Access Compliance Report

Public Rights-of-Way

Intersection ID: N/A	Main Street: SUMMERFIELD RIDGE LN	Cross Street: CALABASSAS LN	Location: NW
ADA ID: 79DC94CD9C24	Ramp Type: PerpDiag	Initial Pass/Fail: Fail	Overall Compliance: No
Codes/Mitigation Info/Possible Solution		Field Measurements/Component Compliance

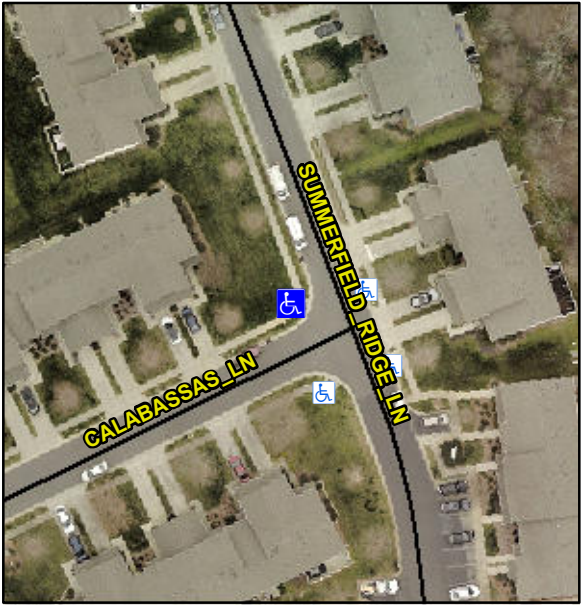
Possible Solutions:	Compliance	Description	Data	Compliance	Description	Data
	Remove & Replace Curb Ramp With Two New Directional Ramps or Equivalent.	N/A	Ramp Length (in)	47.0	No	Ramp Slope (%)	11.5
<p>Surveyor Notes:</p> <p>N/A</p> <p>PROW/ADA:</p> <p>R304.5.1, R304.2.2, R304.5.3</p>		No	Ramp Width (in)	41.0	No	Ramp XSlope (%)	5.2
		N/A	Flare Type LT	N/A	N/A	Flare Type RT	N/A
		N/A	Flare Slope LT (%)	N/A	N/A	Flare Slope RT (%)	N/A
		N/A	Flare Traversable LT?	No	N/A	Flare Traversable RT?	No
		N/A	Landing Length (in)	N/A	N/A	DWS Provided?	N/A
		N/A	Landing Width (in)	N/A	N/A	DWS Contrast?	N/A
		N/A	Landing Slope (%)	N/A	N/A	DWS Length (in)	N/A
		N/A	Landing X Slope (%)	N/A	N/A	DWS Full Width?	N/A
		N/A	Landing Curb? (Y/N)	N/A	N/A	DWS Offset (in)	N/A
		N/A	Shared Landing?	N/A			
		N/A	Gutter Ponding?	N/A	N/A	Gutter Slope (%)	N/A
		N/A	Gutter Lip Ht (in)	N/A	N/A	Gutter X Slope (%)	N/A
		N/A	Painted X Walk1?	No	N/A	Painted X Walk2?	No

X Walk 1 Direction	To S		X Walk 2 Direction	To E
		N/A	X Walk 1 Width (in)	N/A	N/A	X Walk 2 Width (in)	N/A
			X Walk 1 Slope (%)	3.9		X Walk 2 Slope (%)	0.5
			X Walk 1 X Slope (%)	1.0		X Walk 2 X Slope (%)	4.9
		N/A	Ramp inside XWalk1?	N/A	N/A	Ramp inside XWalk2?	N/A
			Road Slope (%)	3.6	N/A	Clear Space?	N/A
			Road X Slope (%)	4.0	N/A	Clear Space to XWalk (in)	N/A
		N/A	Any Obstructions?	N/A	N/A	Storm Grate/Utility Hazard?	N/A
			Obstruction Type			Storm Grate/Utility Type	
					N/A		N/A
					Yes	Surface Condition? (G/P)	Good
Total Cost:		\$	3200.00
